UPS ADDITION
1501 SOUTH POTOMAC STREET
AURORA, CO 80012

DESCRIPTION:
ONE-LINE AND SCHEDULES

E1.1

Re: 1501 S Potomac St Aurora, CO 80012
Review #1

2 PARTIAL ONE-LINE DIAGRAM

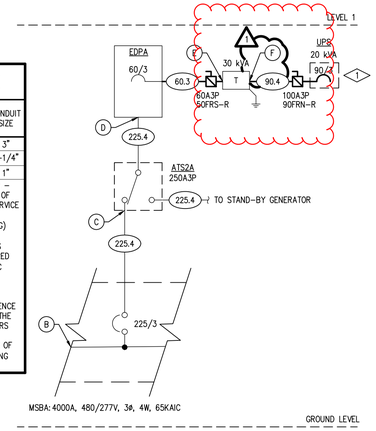
Provide a Grounding Electrode System bonded To the service equipment enclosure, grounded Conductors, and grounded electrode conductors Per 2023 NEC 250.50 and 250.104

All new breakers being installed need have the same aic rating of the panel as well as be of the same manufacturer of the panel they are being installed

Every circuit and circuit modification shall be legibly identified as to it's clear and specific purpose or use. The identification shall include an approved degree of detail that allows each circuit to be distinguished from all others, 2023 NEC 408.4

1. Need impedance of 30 kVA transformer.

MDP Response: *The fault current calculation visibility has been updated to show the impedance of the 30 kVA transformer. The partial one-line diagram was also updated to include the fault calculation point for the secondary side of the 30kVA transformer.*
